CONSTRUCTION PLANS  
FOR  
**THE RIDGE AT LORSON RANCH FILING NO. 1**  
STREET & STORM SEWER CONSTRUCTION PLANS

THE RIDGE AT LORSON RANCH FIL NO. 1  
STREET / STORM SEWER  
CONSTRUCTION PLANS

DATE: NOV, 2021  
PROJECT NO: 100.066  
SHEET NUMBER: C0.1  
TOTAL SHEETS: 49

SHEET NUMBER  
 C6.3

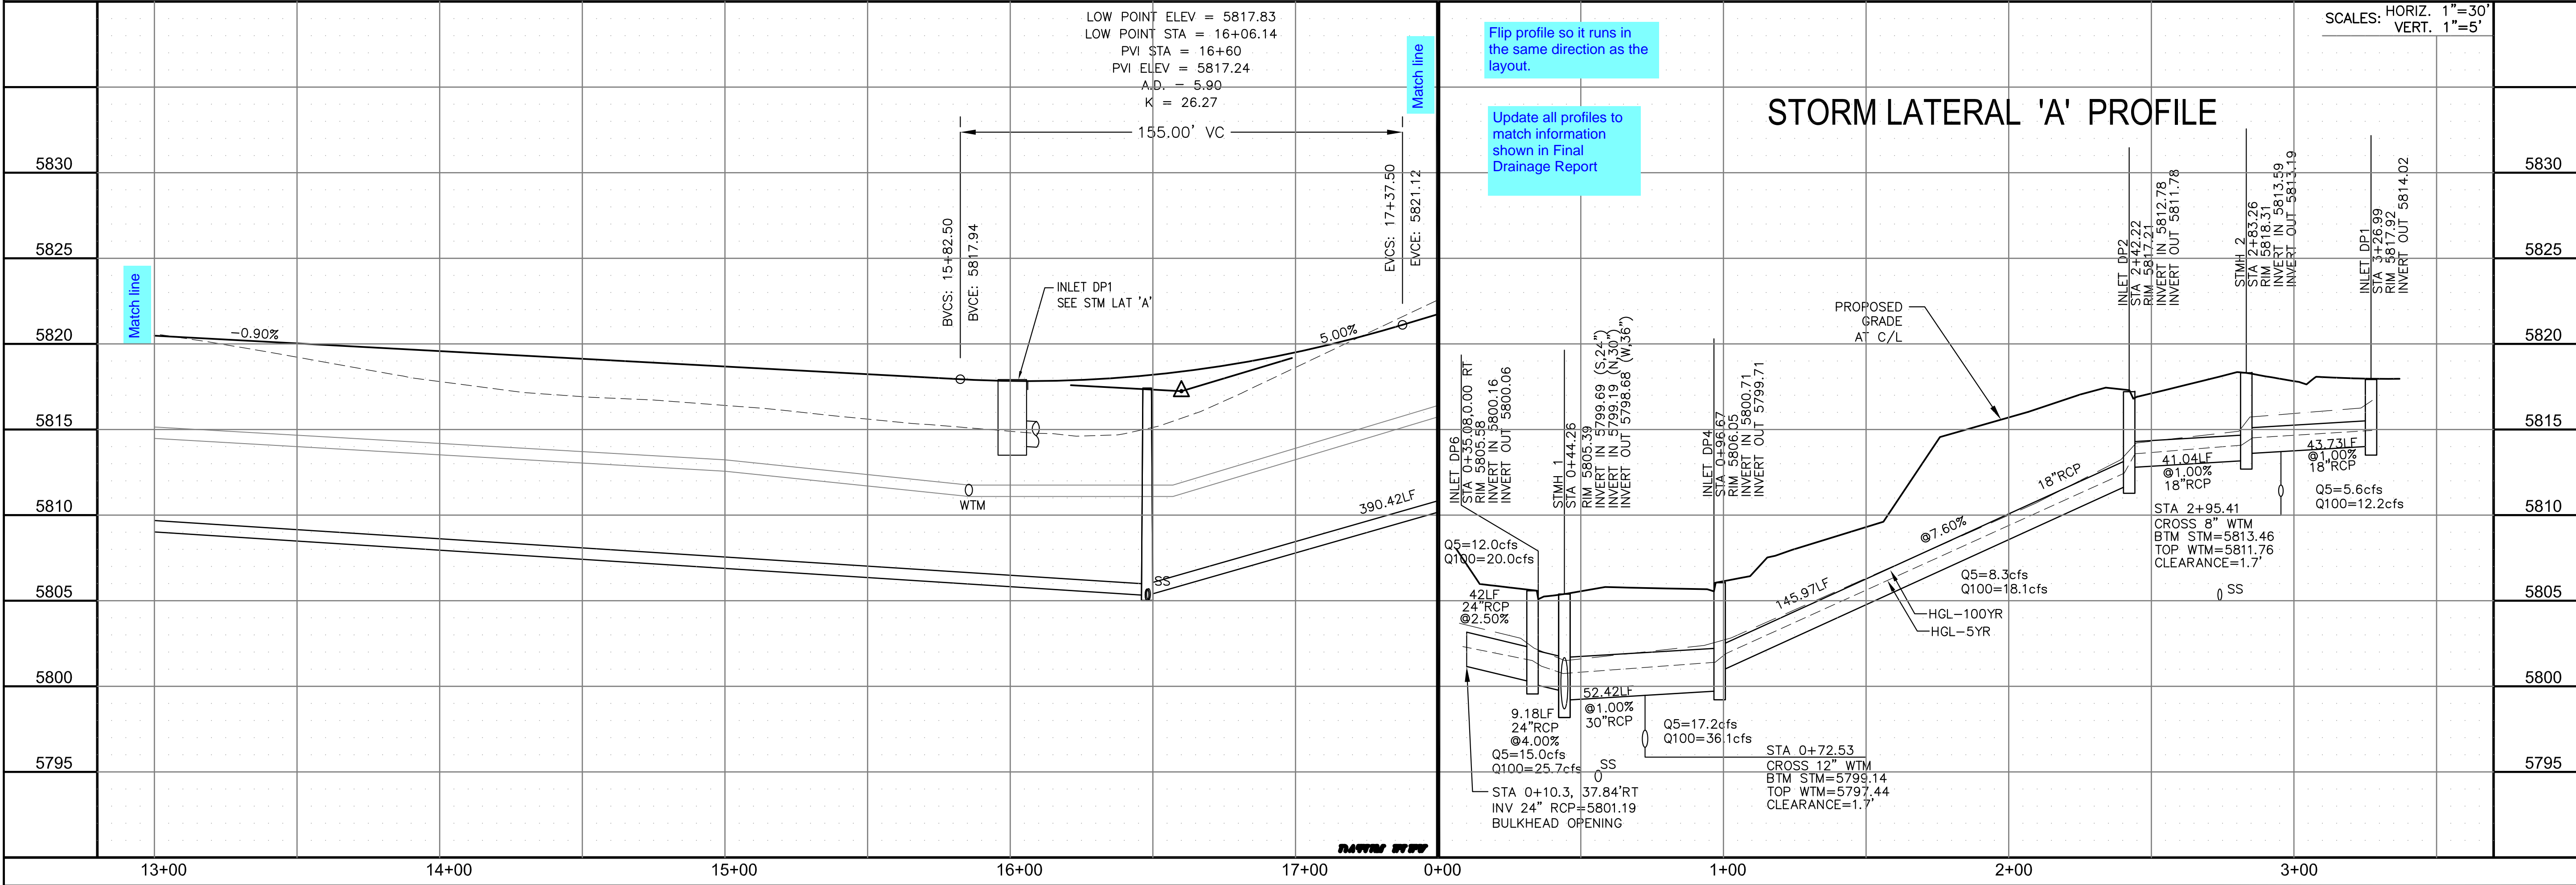
Flip profile so it runs in the same direction as the layout.

DATE: NOV, 2021  
 PROJECT NO. 100.066  
 SHEET NUMBER C6.11  
 TOTAL SHEETS: 49

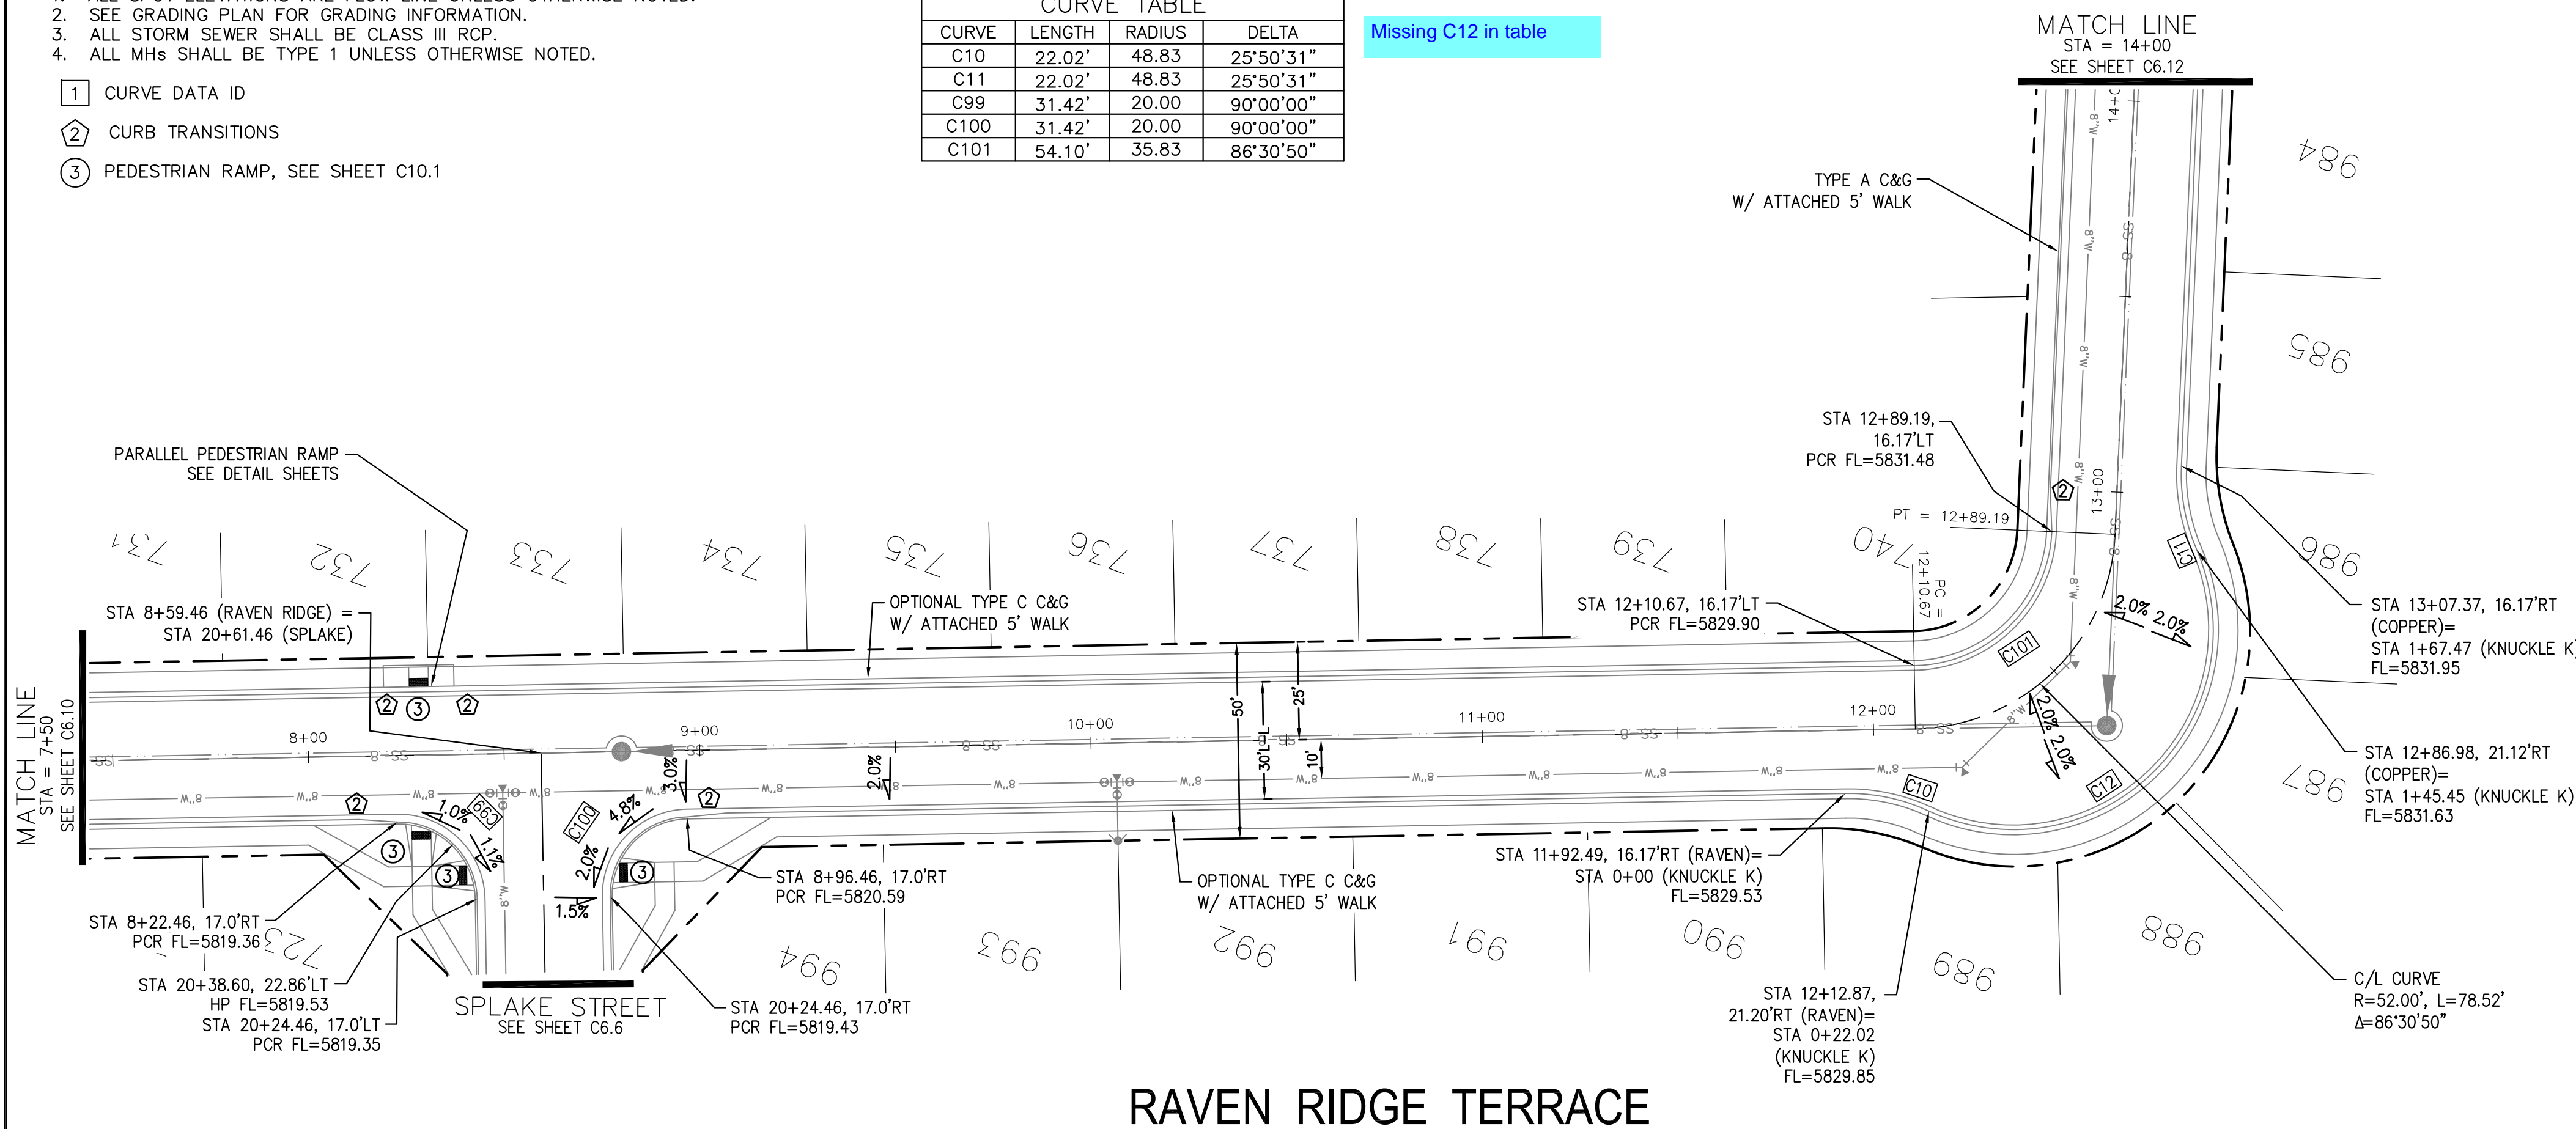
Missing C12 in table

SHEET NUMBER C6.13

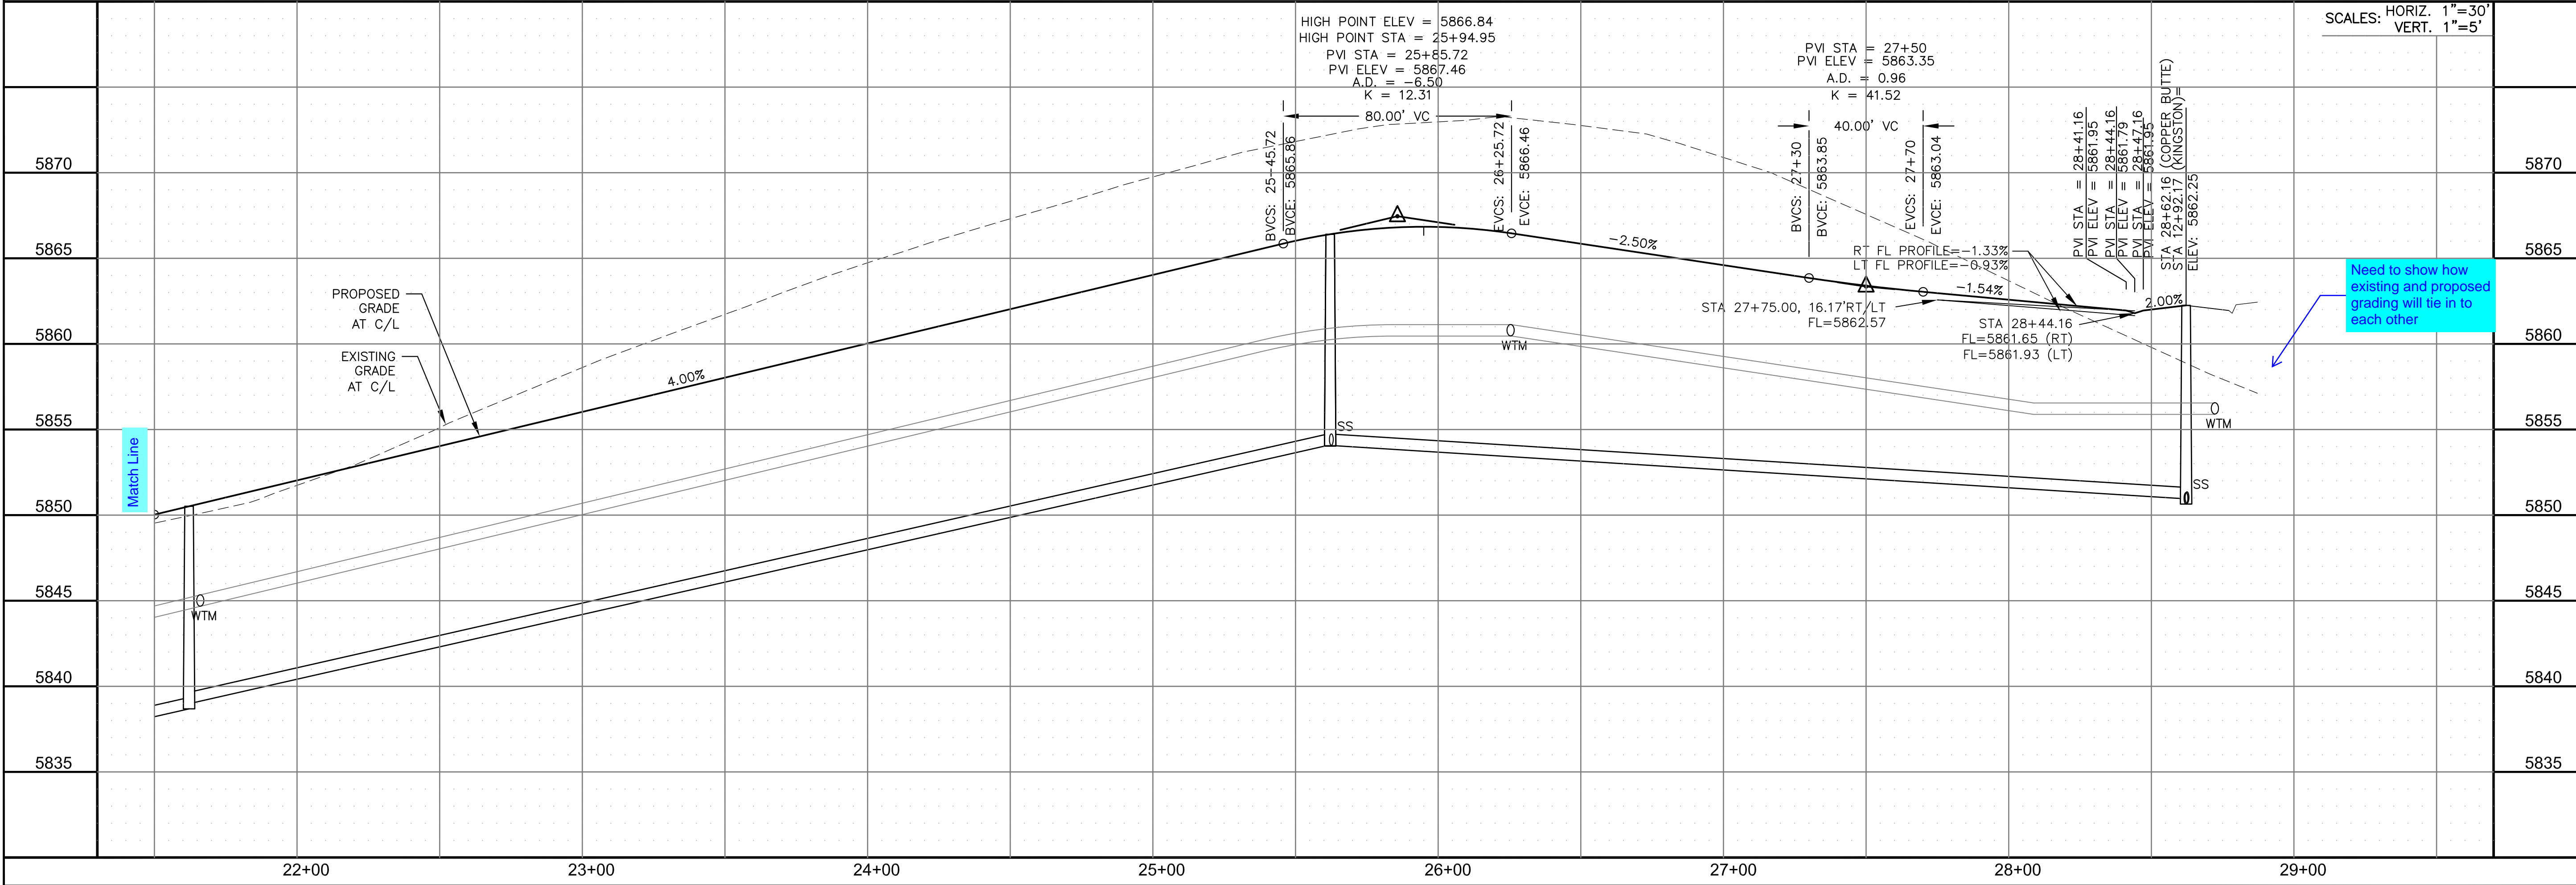
Need to show how existing and proposed grading will tie in to each other

SHEET NUMBER C6.17

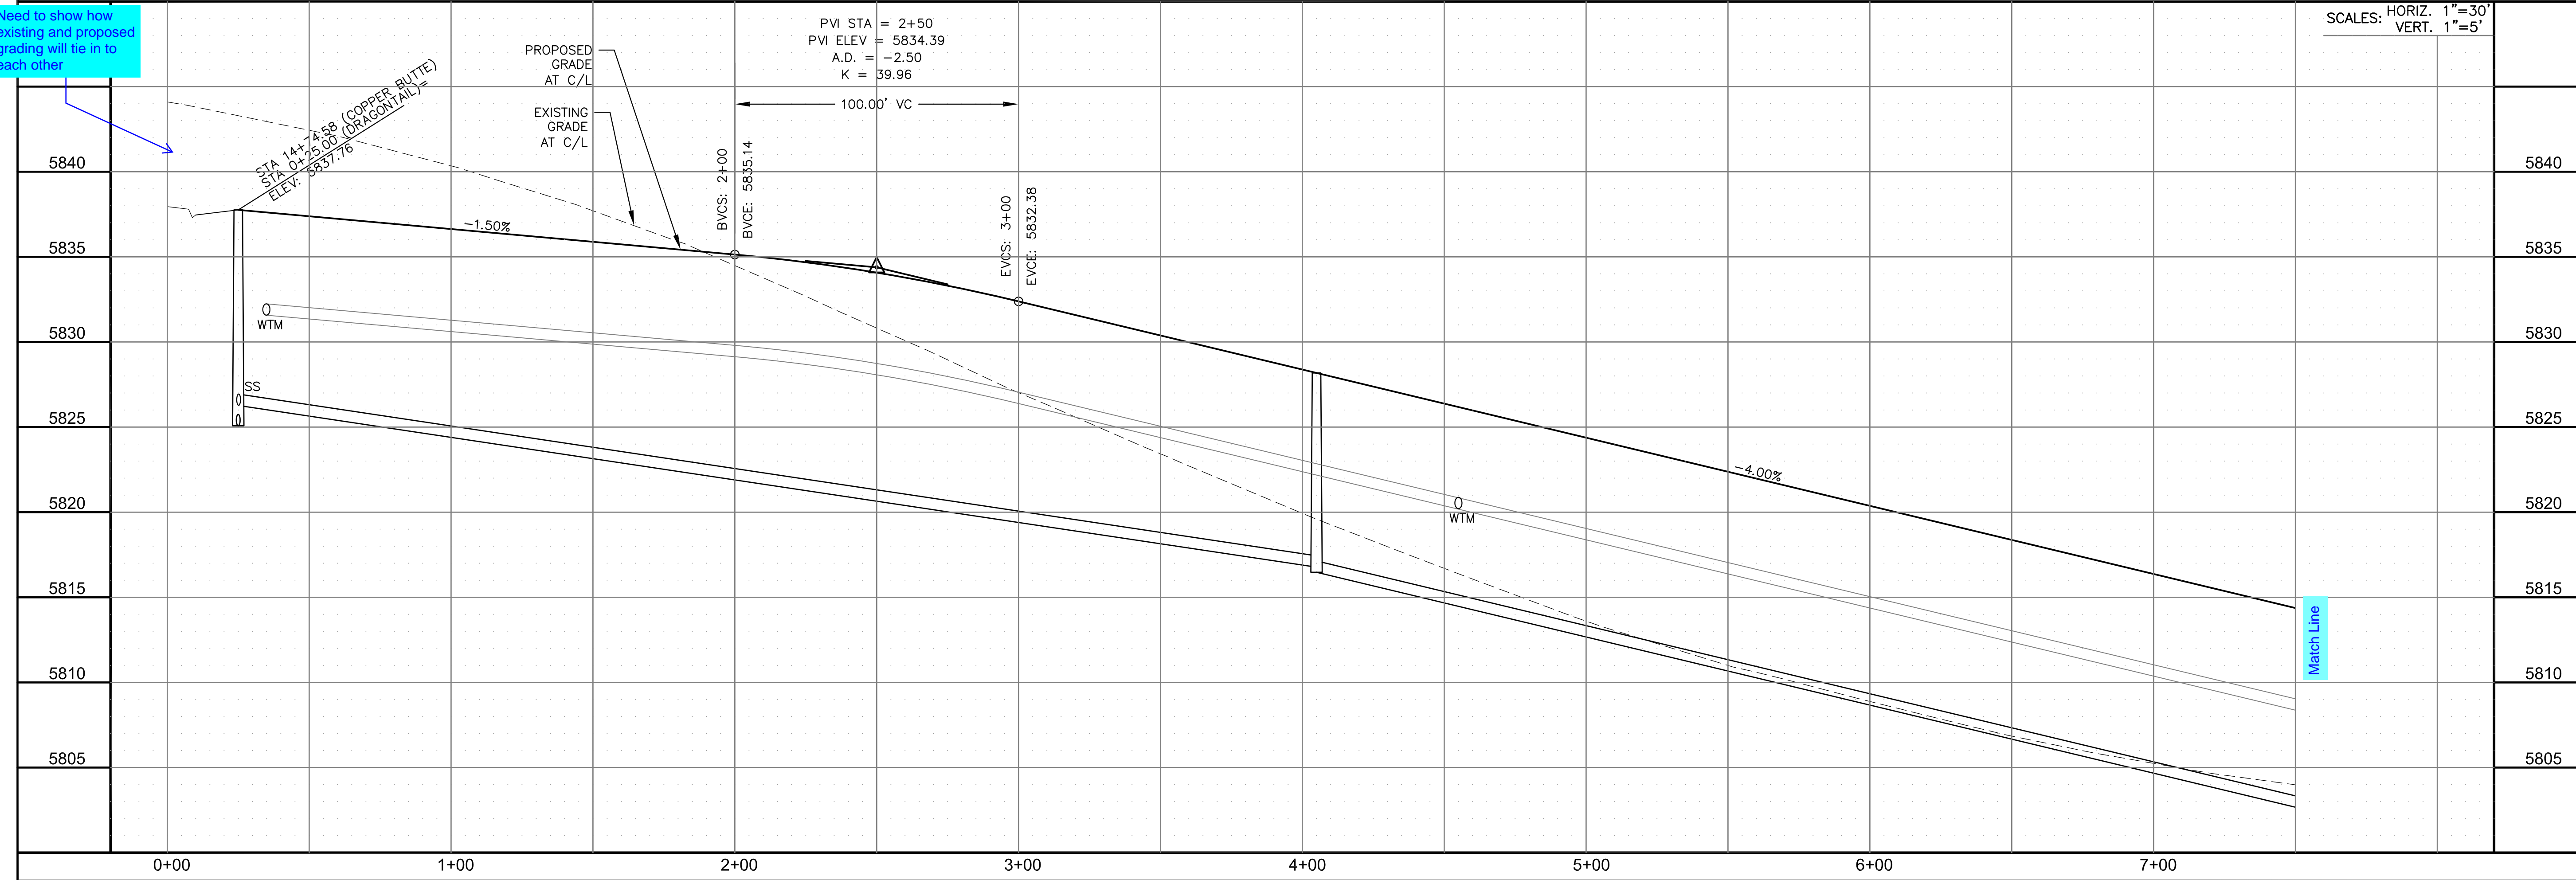
Need to show how existing and proposed grading will tie in to each other
